# TECHNICAL INFORMATION

93048

**Subject** ▶ Change of Hex. flange head bolts M10x20 and M8x12, Box wrench 13, Guard, and Lower fence L  
Elimination of Leaf spring and CT4x16 Tapping screw

**For Models** ▶ LS1016, LS1016F, LS1016FL, LS1016L, LS1216, LS1216F, LS1216FL, LS1216L

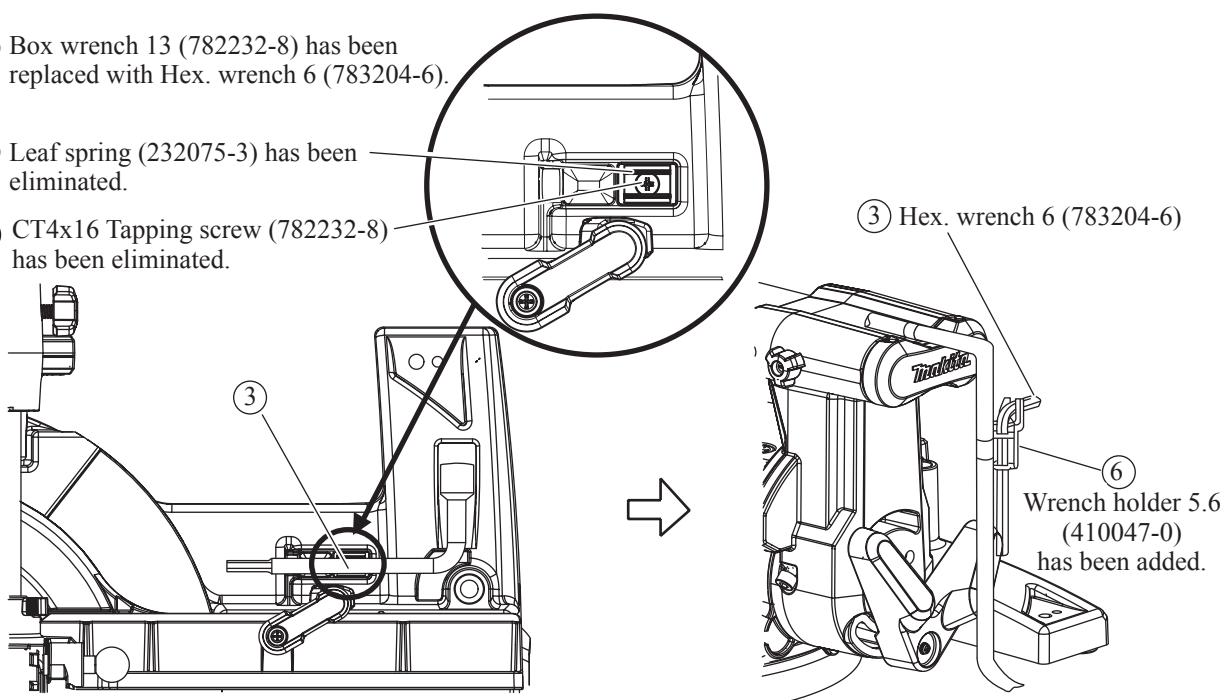
① Change of Blade fixing bolt

Hex. flange head bolt M10x20 (265405-3) → Hex. socket head bolt M10x20 (266755-9)

② Change of Center cover fixing bolt

Hex. flange head bolt M8x12 (265324-3) → Hex. socket hex. bolt M8x20 (266283-4)

③ Box wrench 13 (782232-8) has been replaced with Hex. wrench 6 (783204-6).

④ Leaf spring (232075-3) has been eliminated.

⑤ CT4x16 Tapping screw (782232-8) has been eliminated.
